**NORTHWEST RAPID TRANSIT
PROJECT INTEGRATED MANAGEMENT SYSTEM**

**STORMWATER AND FLOODING MANAGEMENT
PLAN**

**SYDNEY METRO NORTHWEST
OPERATIONS, TRAINS and SYSTEMS PPP**

DOCUMENT NUMBER:	NWRLOTS-NRT-PRD-EN-PLN-300393
REVISION:	C
CONTROL STATUS:	Unmaintained unless stated otherwise

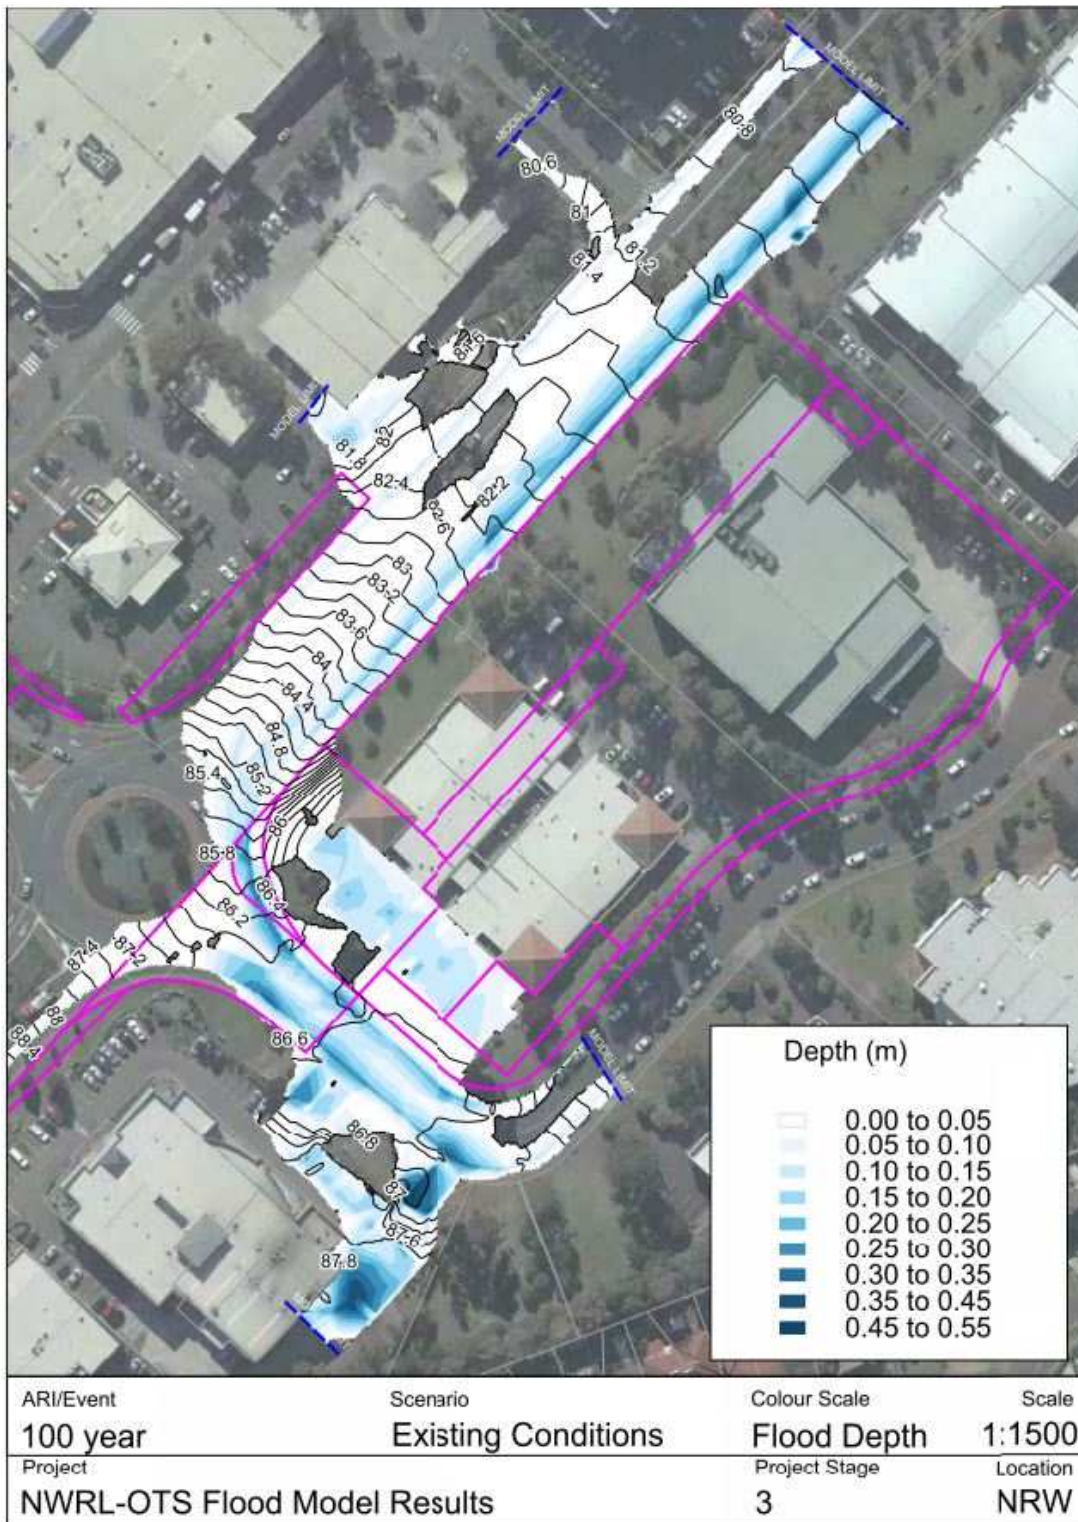
Comments from earlier RFI submission

In response to an earlier RFI submission, TfNSW indicated that further details of mitigating measures would be required to assess the benefits of their execution. Subsequently, the three options developed by the designers were discussed in detail during a collaborative session, and comments/discussion points have been summarized in this report.

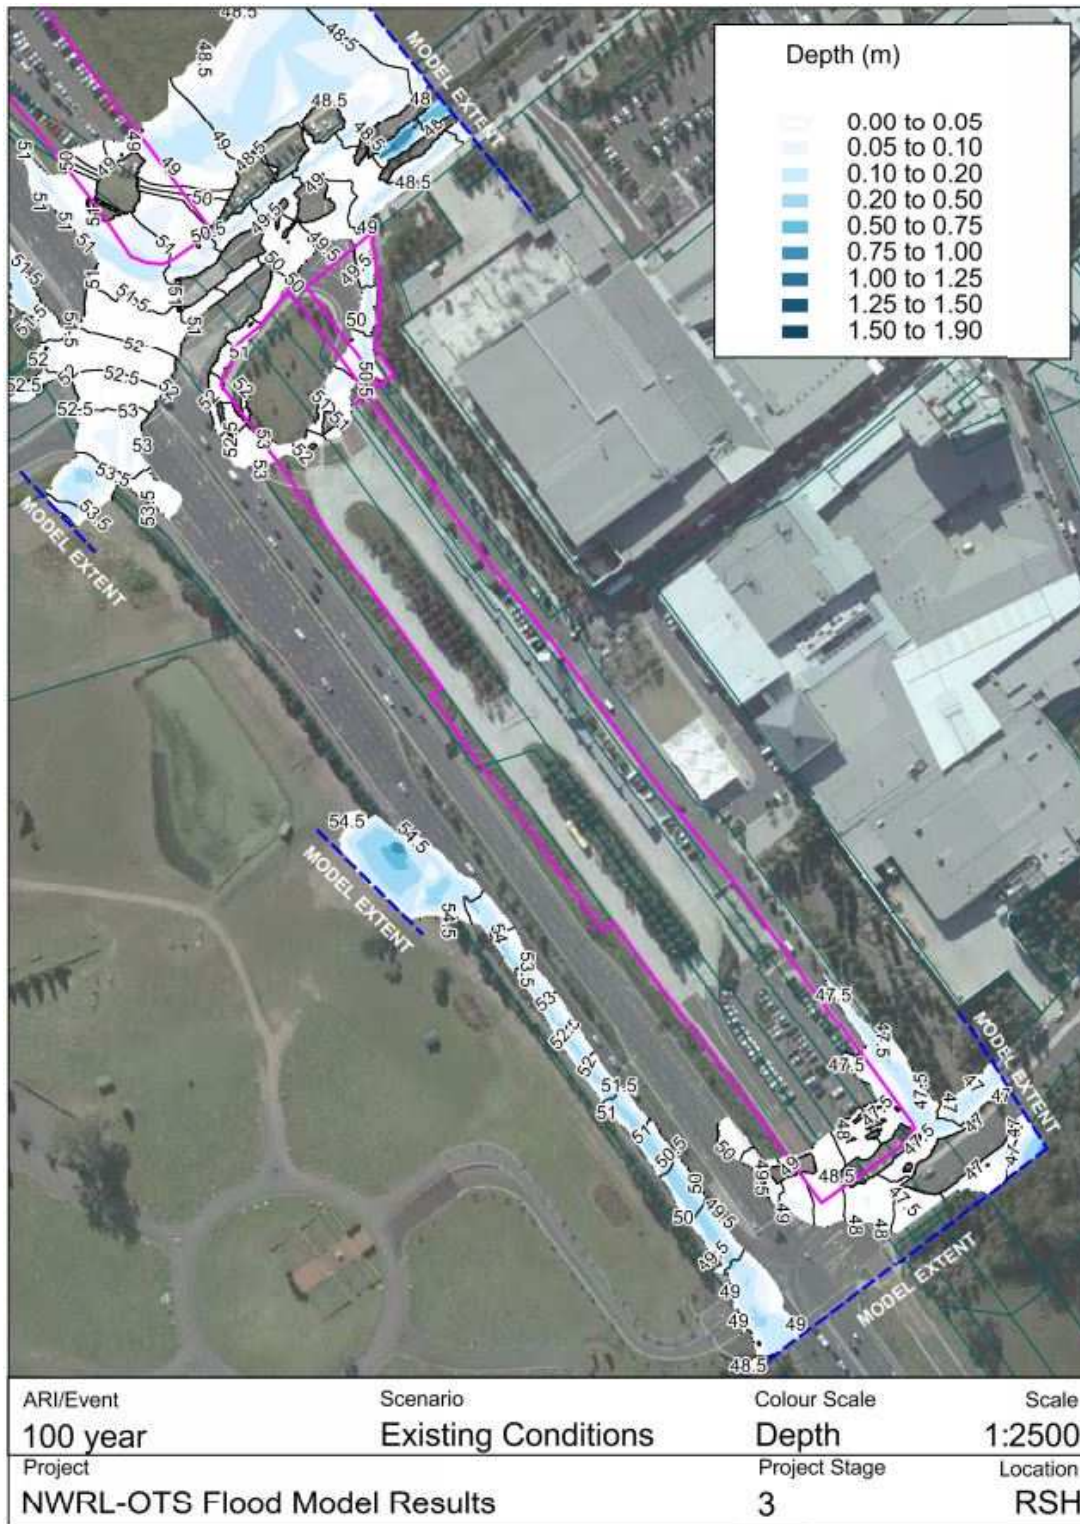
Comments from earlier RFI submission

In response to an earlier RFI submission, TfNSW indicated that they are not in a position to ‘relax’ the deed requirement. This subsequent submission to TfNSW indicates that the DJV considers the design to be in accordance with the deed requirement, given the definitions of feasible and reasonable and their relevance at Rouse Hill, outlined within this document.

A suggestion in the TfNSW response of an afflux mitigating approach centered around the provision of detention for upstream catchments is not considered appropriate. Sydney Water is the managing authority for the catchment and has developed a strategy for the wider management of runoff volumes, peak flows and water quality. Placing development controls on upstream sites over the top of the existing Sydney Water management scheme complicates the management of runoff in the catchment and this additional civil work and associated lifecycle cost for maintenance is not justified as discussed in the flood hazard section in this document.

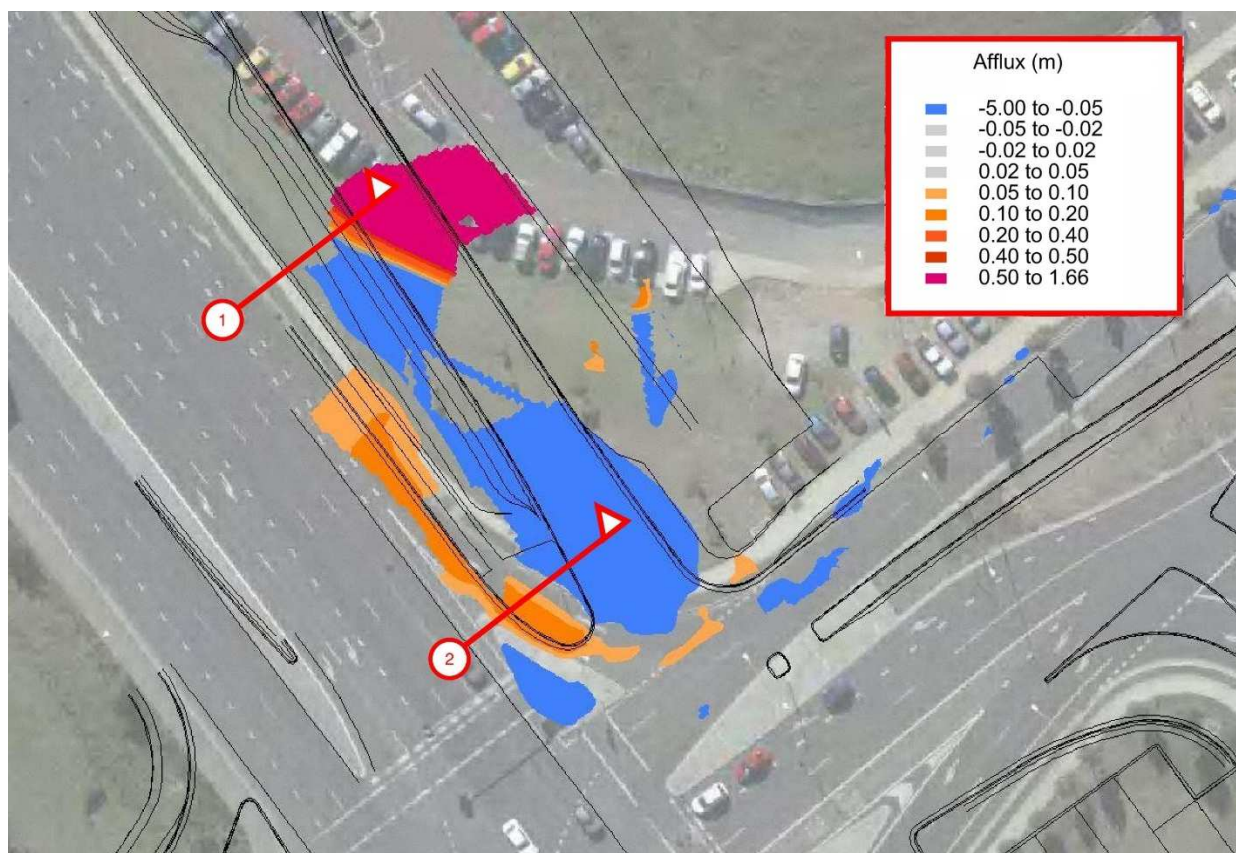
The area of concern is a direct result of changes in grading. The changes in the kerb alignment result in new levels along the kerb and gutter profile with respect to the existing kerb and verge grading.

Water level afflux is generally a criteria used to determine the affects of a flood on mainstream flood levels rather than overland flow paths. This worst case flooding involves overland flows in the order of 0.3-0.4m³/s which is fairly typical of a major road reserve.

This afflux is observed at the peak of the 100 year flood event. This worst case flooding is a result of the 25 minute storm duration, and peak levels last less than 5 minutes before the flooding event has passed.

Cross Section 1 (exaggerated vertical scale, m)

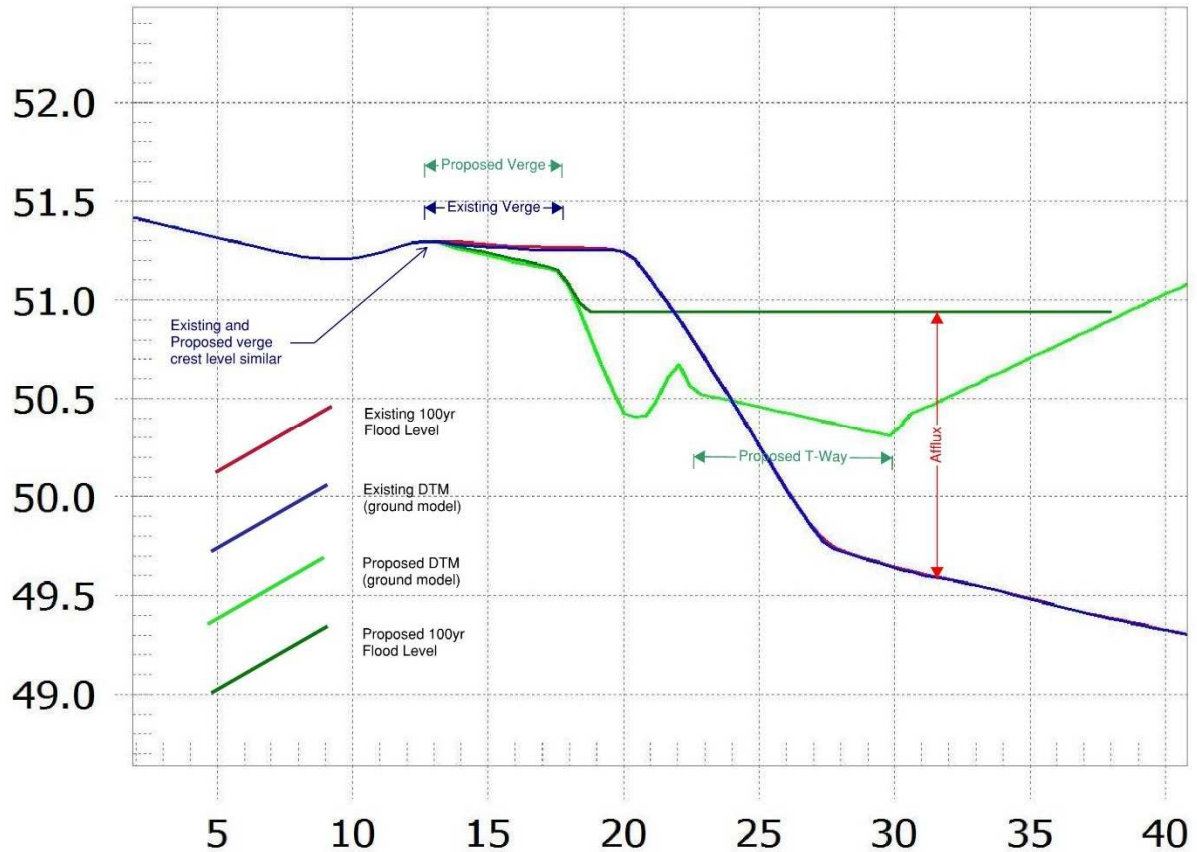
The larger area shaded red in the figure above is a result of the new T-Way alignment which traverses an area in the existing scenario of open grass batter slopes and asphalt carpark. The increase in flood levels is shown below, resulting from the blue existing profile being raised to the light green road reserve to form the T-Way layover. Finished surface levels here are changed by upwards of 1m relative to the existing ground levels.

Cross Section 2 (exaggerated vertical scale, m)

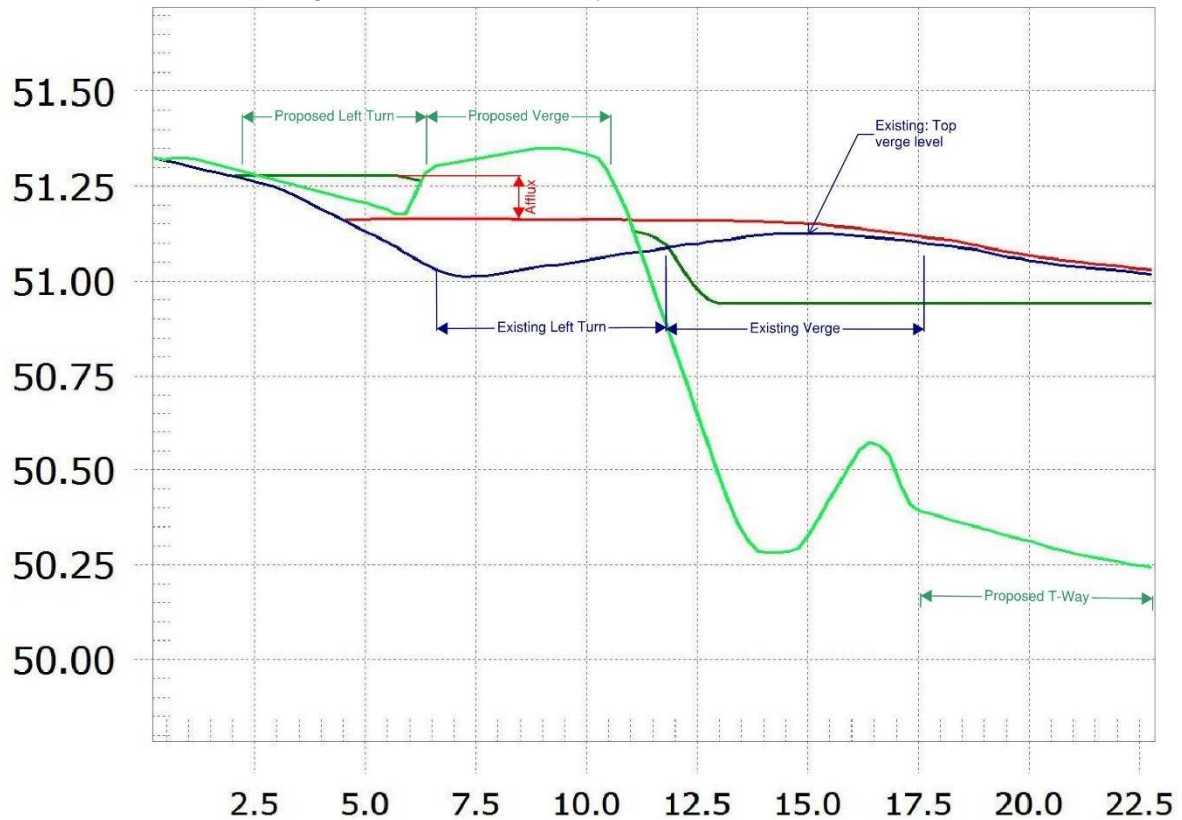
In this cross section the light green profile of the proposed road design shows the shift in kerb position relative to the existing blue profile. Where overland flow occurs within the road pavement of the new green profile, the elevation is higher than the water surface level in the existing scenario (red line). This indicates that regardless of pit capacity in Windsor Road, the configuration of the intersection to achieve the left turn, through traffic and T-Way movements to RMS design standards inevitably results in afflux.
